CITY OF ALBUQUERQUE

October 27, 2022

Re: Arby's Restaurant
6500 Central Ave. SW
Traffic Circulation Layout
Architect's Stamp 10-05-22 (K11-D095)

A3 ARCHITECTURAL SITE PLAN – TCL
SCALE: 1" = 20'-0"

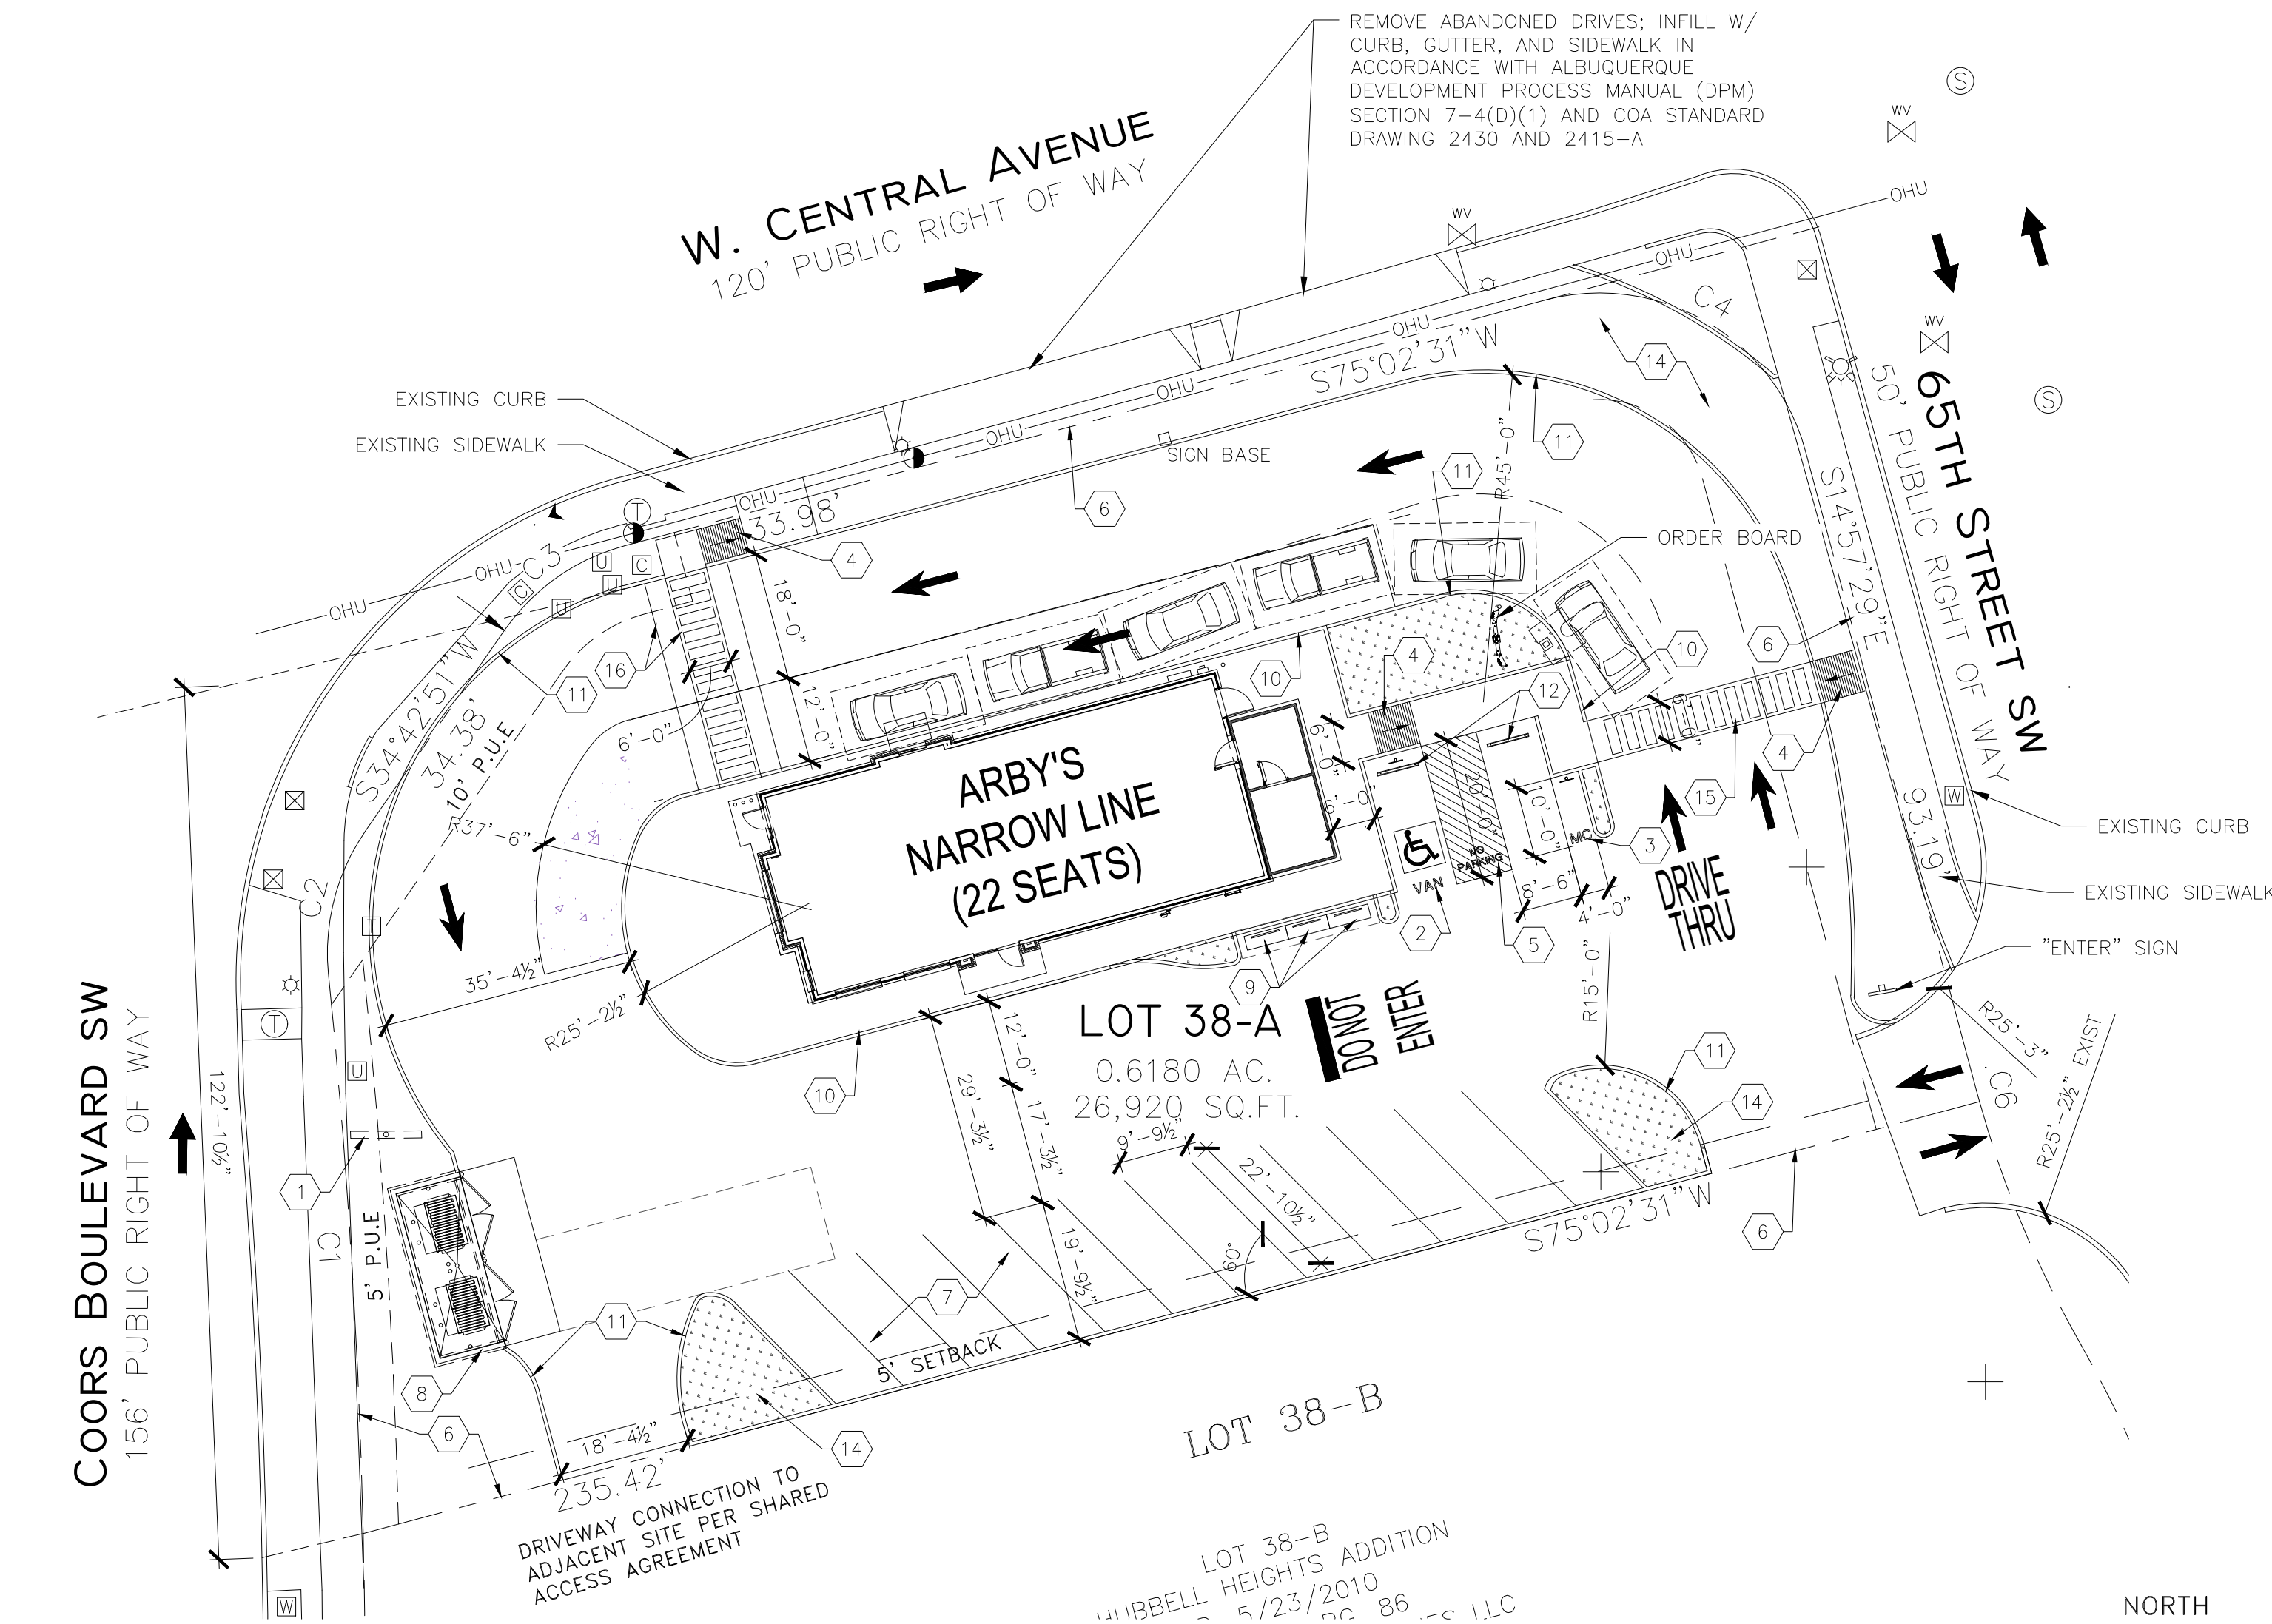
1. Please provide site access driveway width, and the existing access width off 65th St.
2. Shared access agreement between Lot 38-A and 38-B need to be provided. Shared Site access: driveways that straddle property lines, or are entirely on one property but are to be used by another property, shall have an access easement. Please include a copy of your shared access agreement with the adjacent property owner.

3. The ADA accessible parking sign must have the required language per 66-7-352.4C NMSA 1978 **"Violators Are Subject to a Fine and/or Towing."** Please call out detail and location of signs.

4. Motorcycle parking spaces shall be designated by its own conspicuously posted upright sign, either free-standing or wall mounted per the zoning code.

5. Please provide Bike Rack details.
6. All bicycle racks shall be designed according to the following guidelines:
 - a. The rack shall be a minimum 30 inches tall and 18 inches wide.

- b. The bicycle frame shall be supported horizontally at two or more places. Comb/toaster racks are not allowed.
 - c. The rack shall be designed to support the bicycle in an upright position. See the IDO for additional information.

- d. The rack allows varying bicycle frame sizes and styles to be attached.
 - e. The user is not required to lift the bicycle onto the bicycle rack.
 - f. Each bicycle parking space is accessible without moving another bicycle.

7. Bicycle racks shall be sturdy and anchored to a concrete pad.
8. A 1-foot clear zone around the bicycle parking stall shall be provided.
9. Bicycle parking spaces shall be at least 6 feet long and 2 feet wide.

10. The "Do Not Enter" pavement marking should be placed between the land scape island and the motorcycle parking space. "Do Not Enter" and "Stop" sing, should be placed at the same place.

11. Also, please provide "Do Not Enter" and "Stop" sings and pavement marking at the exit of the drive-thru.
12. Details for all the proposed signage and pavement marking need to be provided.

13. Show the clear sight triangle and add the following note to the plan: "Landscaping and signage will not interfere with clear sight requirements. Therefore, signs, walls, trees, and shrubbery between 3 and 8 feet tall (as measured from the gutter pan) will not be acceptable in the clear sight triangle.

14. Clear Sight Triangle need to be shown at the main access off 65th St. and on both site driveways.
15. Please specify the City Standard Drawing Number when applicable.

16. Add a note stating "All broken or cracked sidewalk must be replaced with sidewalk and curb & gutter." A build note must be provided referring to the appropriate City Standard drawing.
